Historic Preservation Review Board
Staff Report And Recommendation

Property Address: **1905-09 Martin Luther King Avenue SE**

Landmark/District: **Anacostia Historic District**

H.P.A. Number: **20-0708**

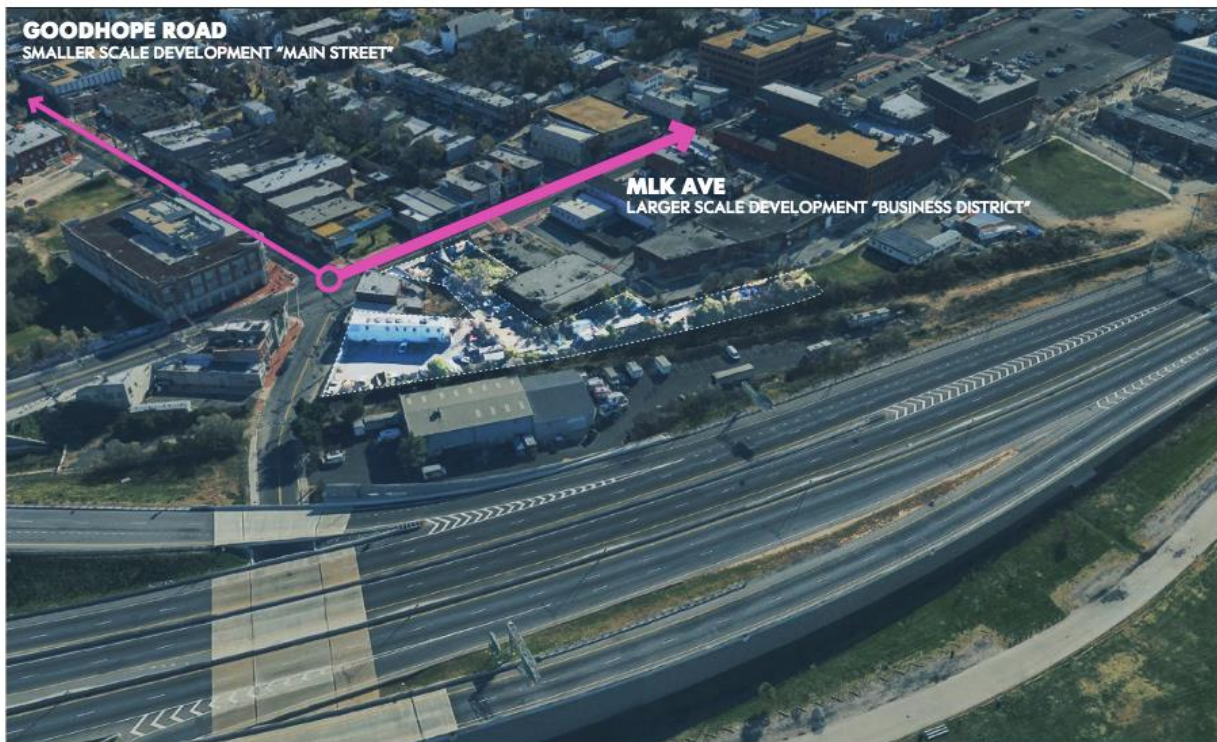
The eastern, MLK Jr. Avenue facing "A" façade is similar to the height variation along Good Hope Road with the approved MLK Gateway I project. The scale of the buildings fronting MLK, while larger than the historic one to two-story buildings, are compatible with the character of the historic district. The fenestration along the "A" façade breaks up the continuous brick buildings into segments that relate to the three bay buildings in the district, and the use of patterned brick is consistent with the brick historic commercial buildings in the historic district. As the design continues to be developed, the storefronts

should be re-designed to have a lower height and smaller scale more in proportion to the storefronts found in the historic district. It is also recommended that the height of the parapet wall on the end building adjacent to U Street should be raised slightly, and that the applicants coordinate with staff on the brick selection and detailing.

The “B” façade doesn’t relate as well to the historic district as the “A” façade. While

located partially outside the boundaries of the historic district, which provides a rationale for greater design flexibility, this is the side that faces the highway and provides an important view into the historic district. While the rear façade does not need to resemble or reflect the historic character of the buildings on MLK Avenue, further design consideration of the repetitive metal paneling material and the continuous single pane fenestration could improve the relationship of this portion of the building with the MLK-facing façade and the historic district.

The HPO recommends that the Review Board find the height, massing and general design direction of the project to be compatible with the character of the historic district, but that refinement of the storefronts and additional study of the “B” façade be undertaken to improve the project’s compatibility with the historic district.
